RIVER PODDLE FLOOD ALLEVIATION SCHEME

RESPONSE TO REQUEST FOR FURTHER INFORMATION

**SOUTH DUBLIN COUNTY COUNCIL & DUBLIN CITY COUNCIL IN
ASSOCIATION WITH THE OFFICE OF PUBLIC WORKS****RIVER PODDLE FLOOD ALLEVIATION SCHEME****FURTHER INFORMATION RESPONSE**

PROJECT NO. 20662					
Revision	Reason for Revision	Prepared by	Reviewed by	Approved by	Issue Date
-	First Issue for Review	LMG, BD, JH, RC	BD, LMG & CAS	JO	09/10/2020
Final	Final for RFI Submission to ABP	LMG, BD, JH, RC	BD, LMG & CAS	JO	19/10/2020

Figure 6-4. Finished contour plan for Whitehall Park channel re-alignment

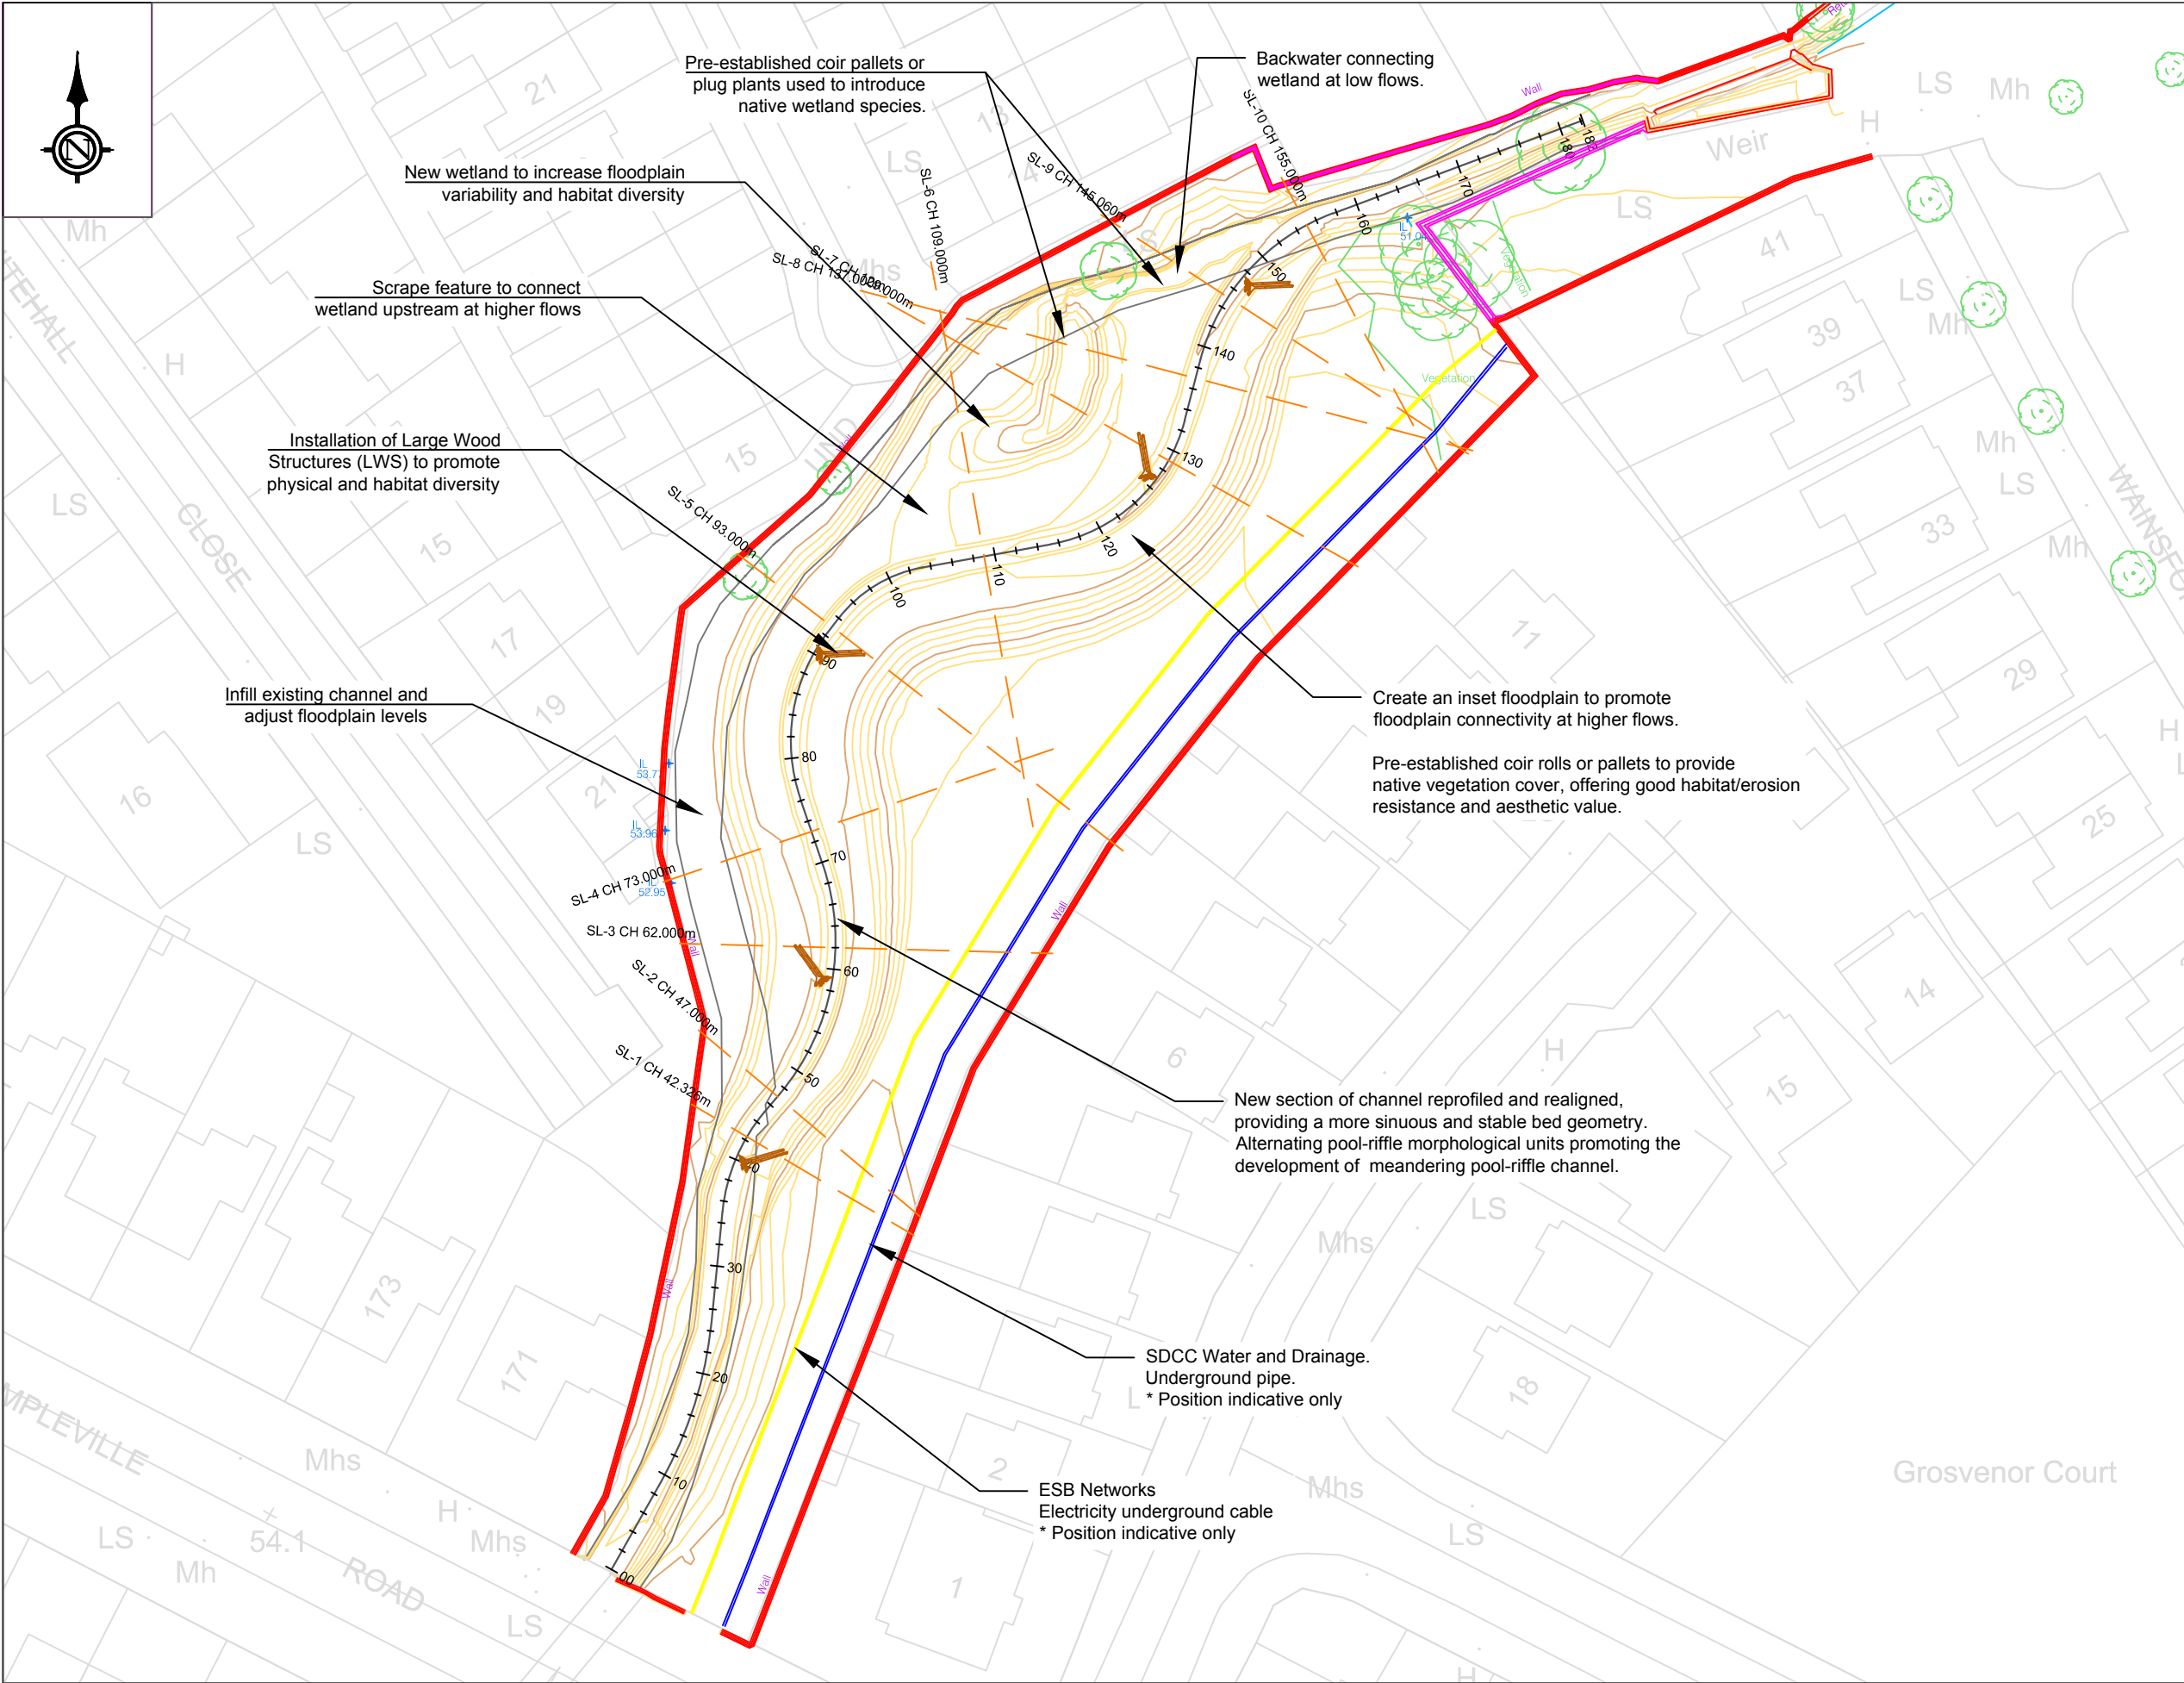
RFI 5. Further detail is required on the proposals for river re-alignment at Whitehall Park including in relation to the construction phase and the finalised alignment of the river channel. In addition, it is noted that landscaping proposals along the river banks appear to be incorrectly described. There is reference in Chapter 10 of the EIAR to the creation of steep grassed terraces while the description of the scheme elsewhere suggests that these terraces are no longer proposed. In this context please clarify the proposed development and undertake any revisions to the application documentation.

As shown on the plan in **Figure 6-4**, each LWS will be positioned to be directed into the flow at an angle of between 30° - 45° and will extend one third of the way across the channel with the root plate directed into the flow and a length of the wood to be buried into the bank for stability. Where possible, the wood should be sourced locally. Associated with an appropriate planting scheme, these in-channel features and the design geometry will support the evolution of a more natural environment with improved aesthetic appearance and the potential to contain fine sediments.

A small wetland / backwater feature has been incorporated into the design on the left-hand side of the river towards the downstream extent of the site (see **Figure 6-5**). Creation of this wetland involves regrading parts of the existing channel bed and excavating areas of surrounding floodplain, creating a deeper 'ponded' section surrounded by shallower, marginal areas. The wetland has been designed with a connecting channel at the downstream extent, set at an elevation to allow for the partial inundation of the feature under the estimated low flow of 0.5 m³/s, and to allow flow to enter the wetland from the upstream extent at the approximated bank full flow (*i.e.* ~1.0 m³/s).

FIGURE 7-2

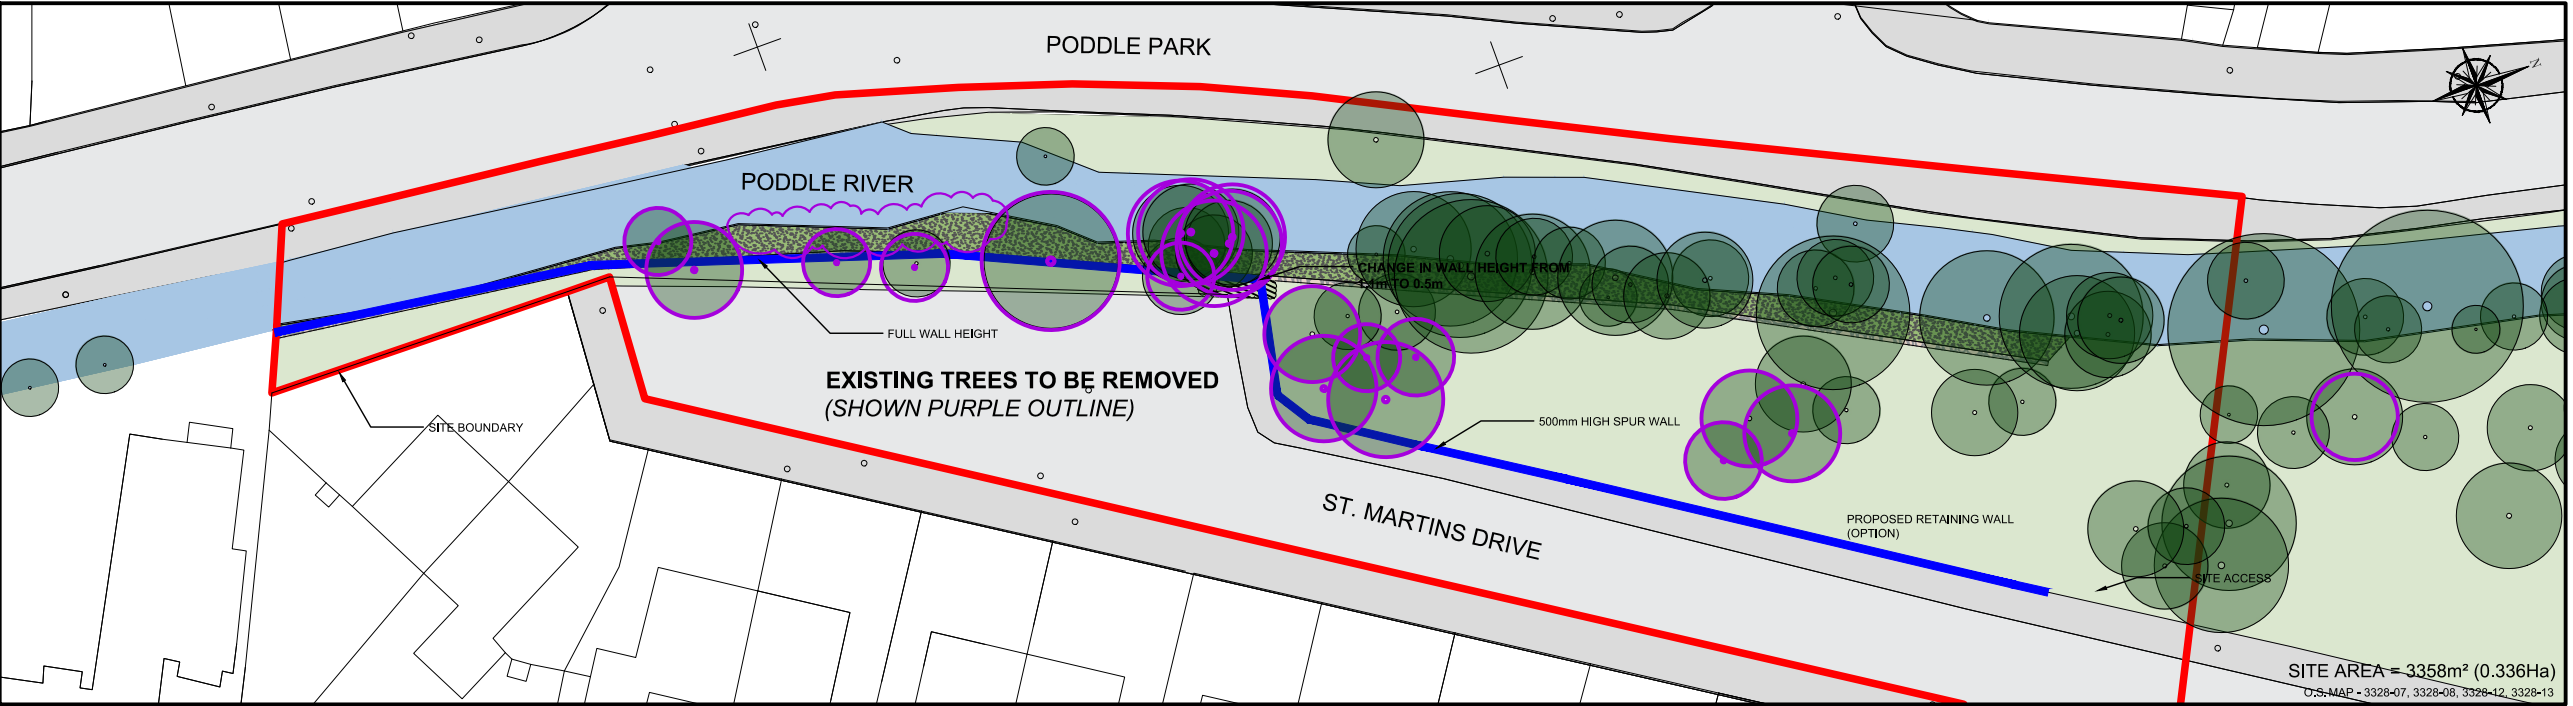
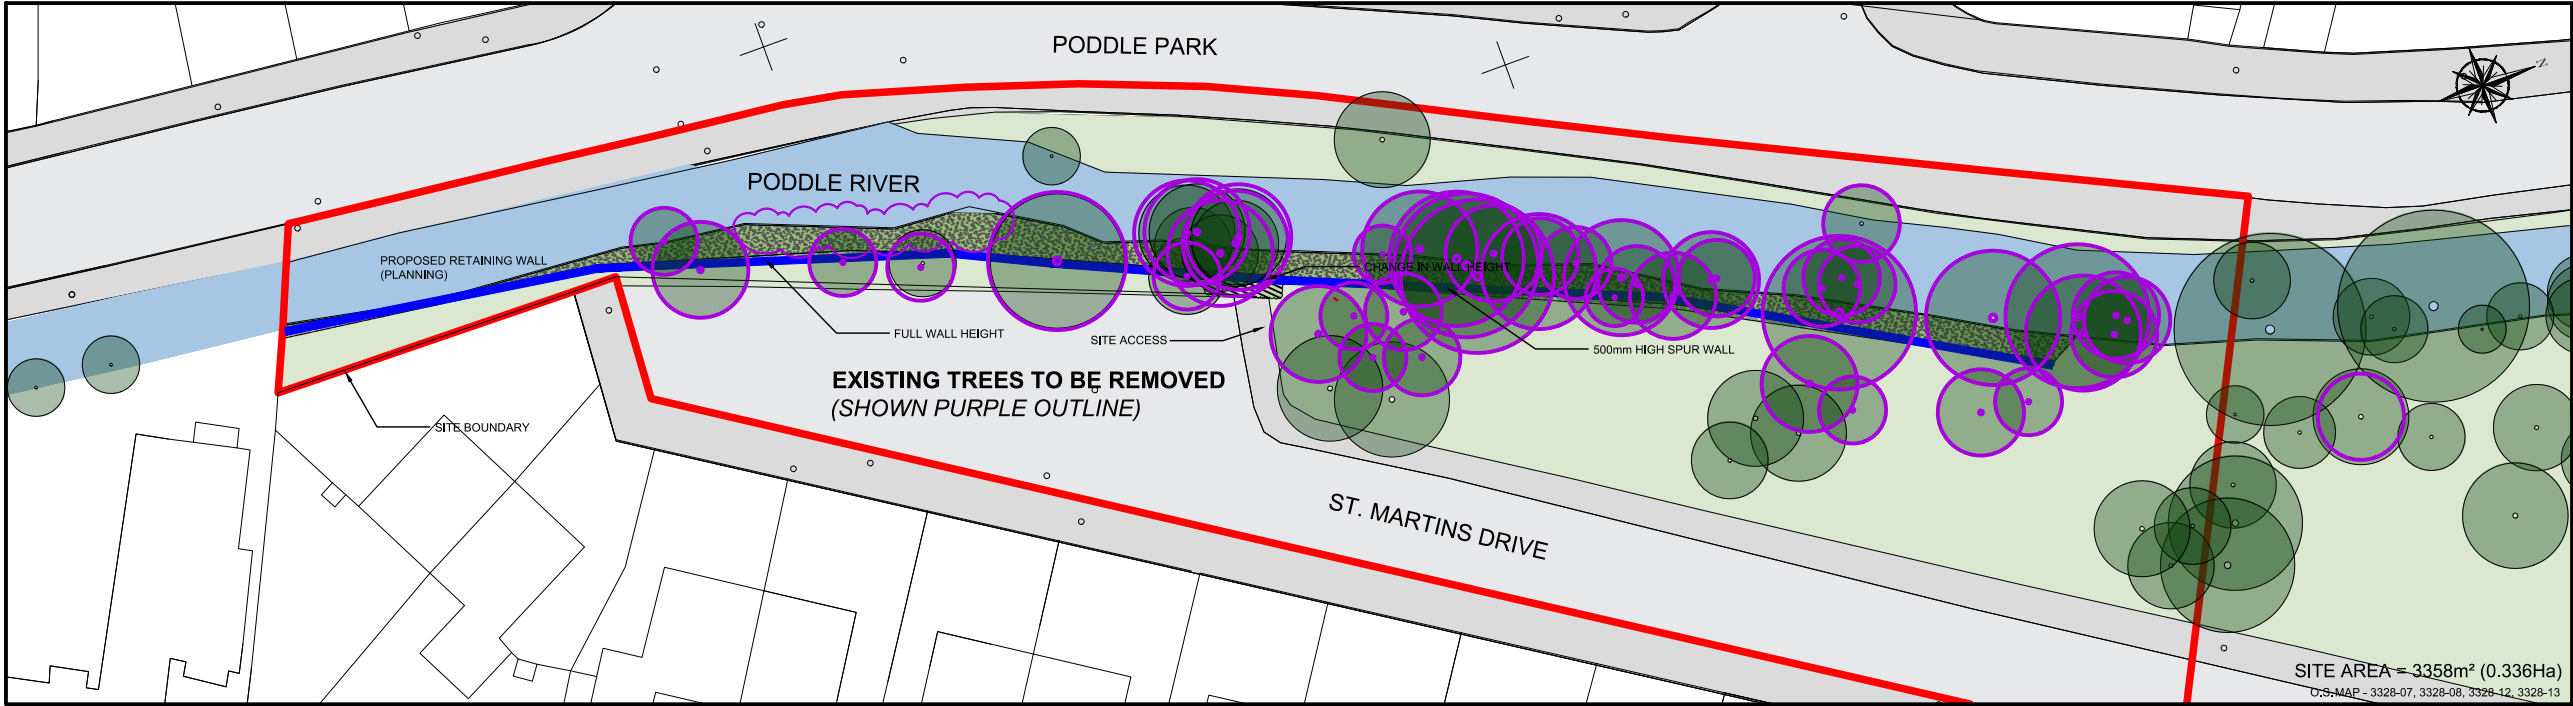
RFI 6. Regarding St Martin's Drive you are requested to provide further information on Option 1, including detailed drawings showing the height and location of walls and information quantifying the extent of tree loss. The submission should provide sufficient detail to enable a comparison to be made between the two options. You are also requested to provide an assessment by the project ecologist of the two options. It is anticipated that you will have addressed the option of a transparent or demountable structure in your observation responses.

A discussion of the environmental effects of the different options is provided below. Reference is made to the illustration provided in **Figure 7-2** which provides a visual aid for comparison of the two options.

While this option does result in 13 no. more trees being removed along the riverbank when compared to Option 1, this amount of tree loss will not significantly alter the access, view or use of the green space for local residents. A wall along the riverbank allows for effective replanting of new trees and shrubs in front of the wall as shown in **EIAR Volume 3**, St. Martin's Drive Landscape Mitigation Plan. Based on the above, this option was selected as the preferred option and presented in the proposals for planning permission.

- Install a soft geo/ bio textile frontage to the required flood wall on river right. Suggested materials are rock roll (closest to the flood wall) then planted coir roll, *etc.*
- Use strategic placement of Wood Structures (WS) to encourage the development of greater physical heterogeneity and flow diversity, including pools and areas of sediment aggradation.
- Encourage colonisation by native vegetation (potentially including trees), enhanced by planting to mitigate the removal of potential vegetation.

Figure 19-1. Location of the Brent Geese Feeding Area Relative to the Proposed Development

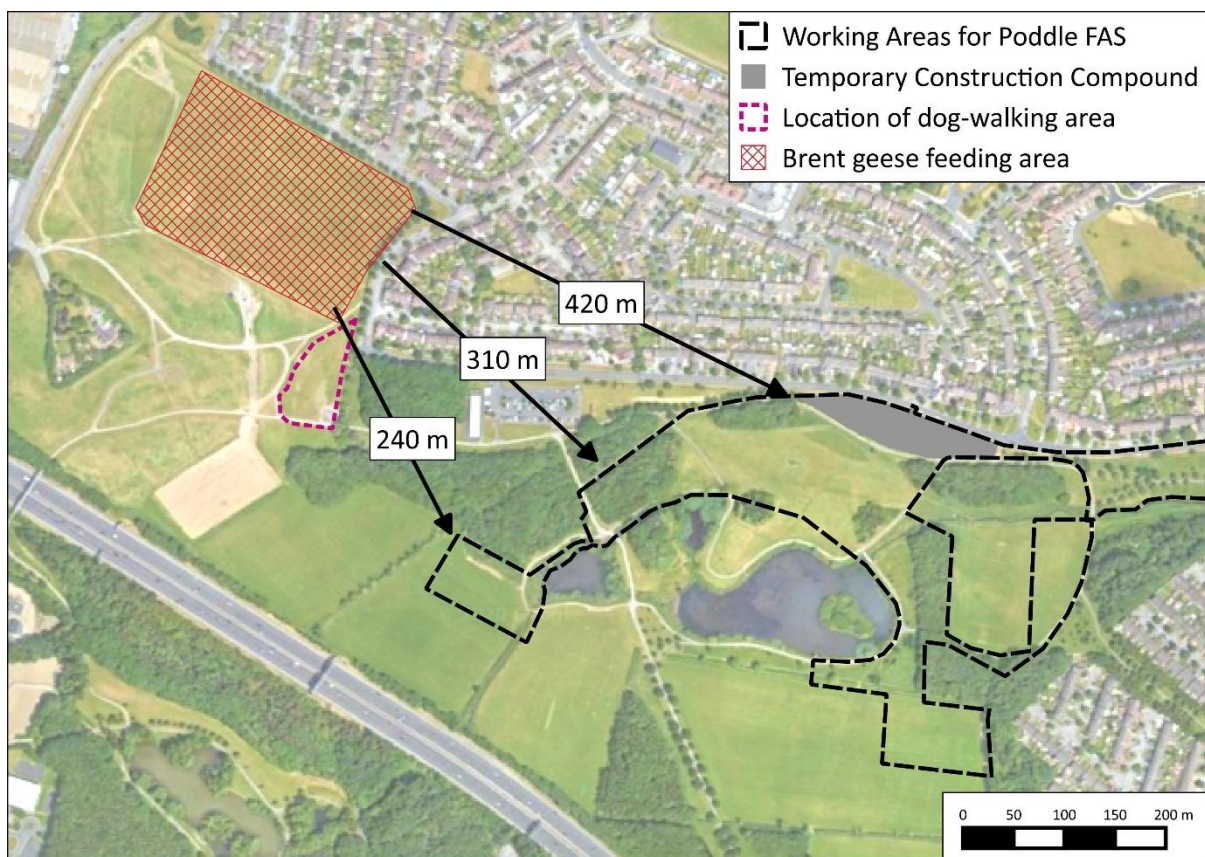
18. Temporary works include establishing a main construction compound in Tymon Park, which will be in operation for the entire duration of the works in addition to the works proposed to take place within Tymon Park. You are requested to provide details of any possible (ex-situ) disturbance effects on Light Bellied Brent Geese, which occasionally use Tymon Park.

The brent geese feeding area in Tymon Park is a playing field adjacent to Keaden Avenue / Lugnaquilla Road / Kippure Avenue. **Figure 19-1** shows the distances between the feeding area and various components of the proposed development.

The linear distance between the main construction compound in Tymon Park and the brent geese feeding area is approx. 420m. Other construction work in the area includes an embankment to the north-west of the Tymon Lakes (approx. 310m from the feeding area)
